HISTORIC AND DESIGN REVIEW COMMISSION

December 02, 2015

Agenda Item No: 2

HDRC CASE NO: 2015-391
COMMON NAME: 500 E Martinez St
LEGAL DESCRIPTION: NCB 901 ALL OF BLOCK EXC LOTS 44, 45 & 46
ZONING: C3R H
CITY COUNCIL DIST.: 1
DISTRICT: Lavaca Historic District
APPLICANT: Gary Boyd/City of San Antonio
OWNER: City of San Antonio
TYPE OF WORK: Final approval of a temporary parking lot
REQUEST:

TRUEGRID[®] PRO Plus Manufacturer's Product Specification Sheet

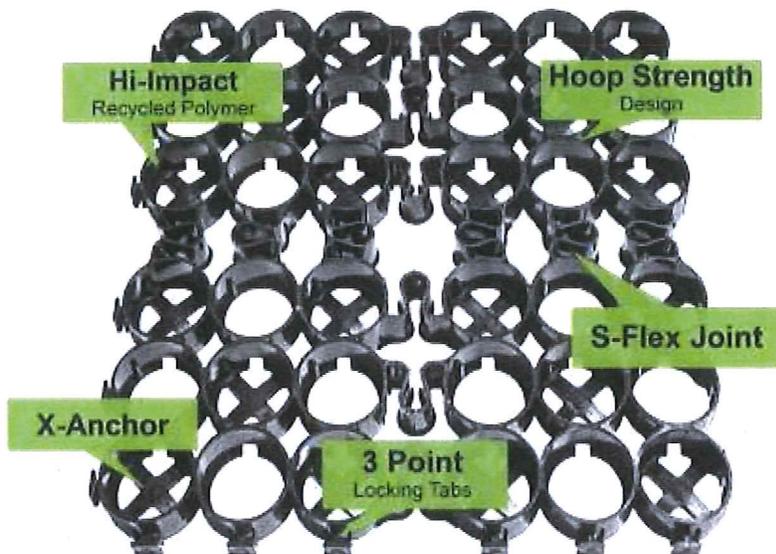
- g. The applicant has proposed to install a TRUEGRID Permeable Paver system which will allow for a pervious paving service, reducing the impact of the proposed parking lot. Staff commends the applicant for selecting a pervious paving solution of the previously proposed asphalt paving.
